SERVICE BULLETIN

ENGINE - FUEL AND CONTROL - ENGINE - ELECTRONIC ENGINE CONTROL - PROVIDE A NEW ELECTRONIC ENGINE CONTROL (EEC) WITH THE SCN12D SOFTWARE CONFIGURATION - CATEGORY CODE 4 - MOD.ENG-73-0082

V2500-ENG-73-0082

Location of the Electronic Engine Control (EEC)
Fig.1

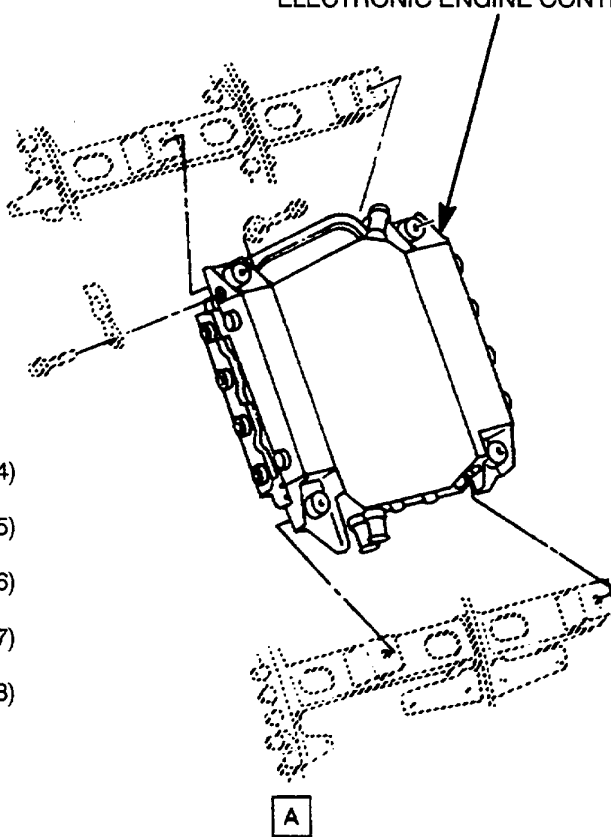
- (1) Remove the 808050-4-046 (2A3148), 798300-15-046 (2A3149), 798300-16-046 (2A3150), 798300-17-046 (2A3151) or 798300-18-046 (2A3153) Electronic Engine Control by the approved procedure given in Reference (6), Chapter/Section 73-22-34, Removal/Installation. Refer to Figure 1.

REMOVE THE ELECTRONIC ENGINE CONTROL, DO THE CHANGE SPECIFIED, IDENTIFY AND INSTALL THE NEW ELECTRONIC ENGINE CONTROL (1 off) *

- (1) Install the 808050-04-048 (2A3224), 798300-15-048 (2A3225), 798300-16-048 (2A3226), 798300-17-048 (2A3227) or 798300-18-048 (2A3228) Electronic Engine Control (1 off) by the approved procedure given in Reference (6), Chapter/Section 73-22-34, Removal/Installation. Refer to Figure 1.

808050-04-048 (2A3224)
OR
798300-15-048 (2A3225)
OR
798300-16-048 (2A3226)
OR
798300-17-048 (2A3227)
OR
798300-18-048 (2A3228)

Location of the ACC Front Duct Cover Assembly
Fig.2

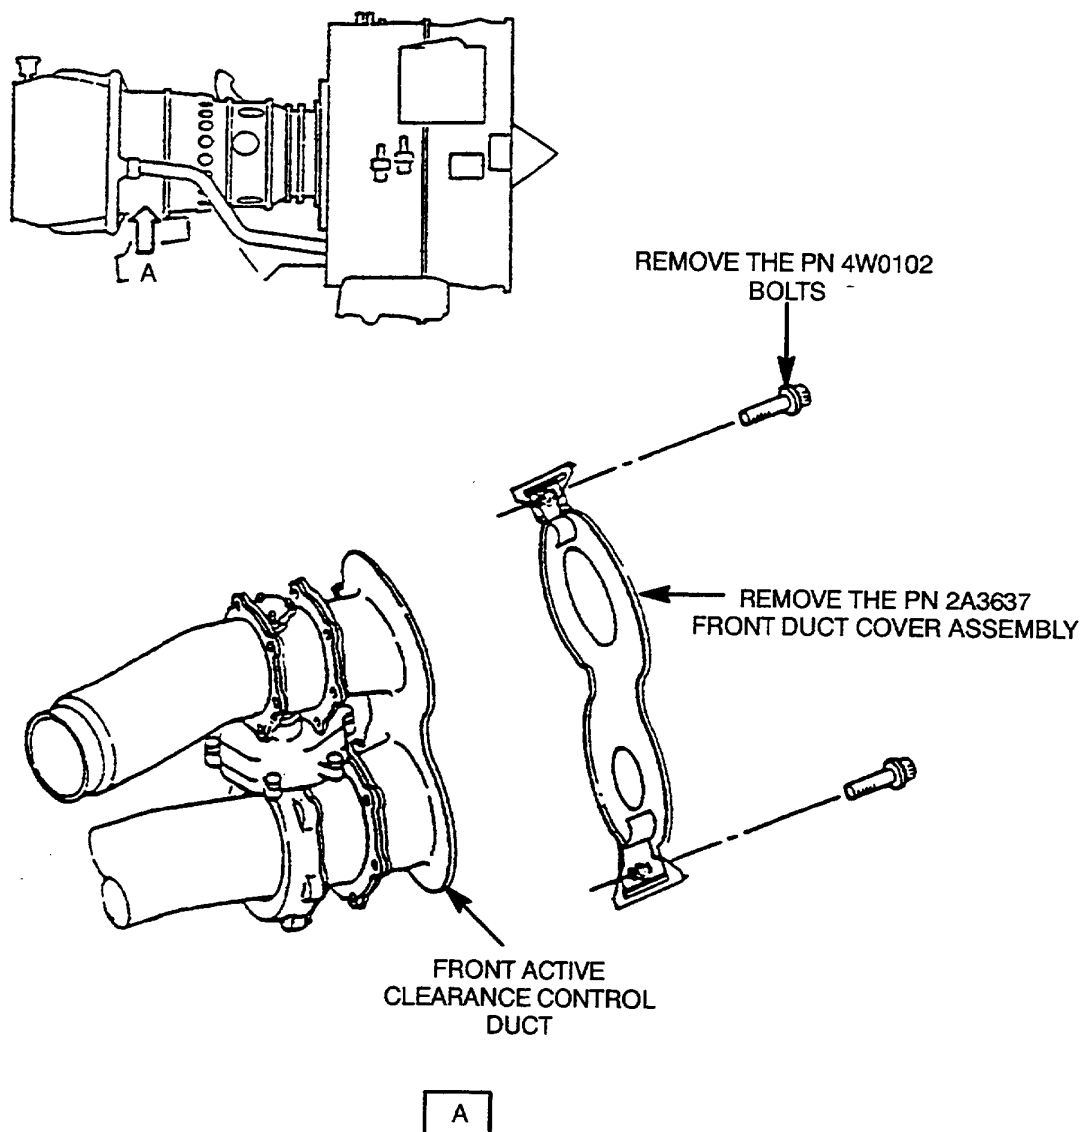
- (a) Send the Electronic Engine Control to the approved vendor to be modified. See paragraph 2.B. See Figure 1.
- (2) Remove the Active Clearance Control (ACC) Front Duct Cover Assembly. Refer to V2500-ENG-75-0025 specified in Reference (1), and Figure 2.
 - (a) Locate the Front ACC Duct.
 - (b) Remove the two 4W0102 Bolts from the Front Duct Cover Assembly.
 - (c) Remove the 2A3637 Front Duct Cover Assembly.

NOTE: When you incorporate this Service Bulletin with the new SCN12D software logic, the Front Duct Cover Assembly given in V2500-ENG-75-0025 must be removed. See Reference (1).
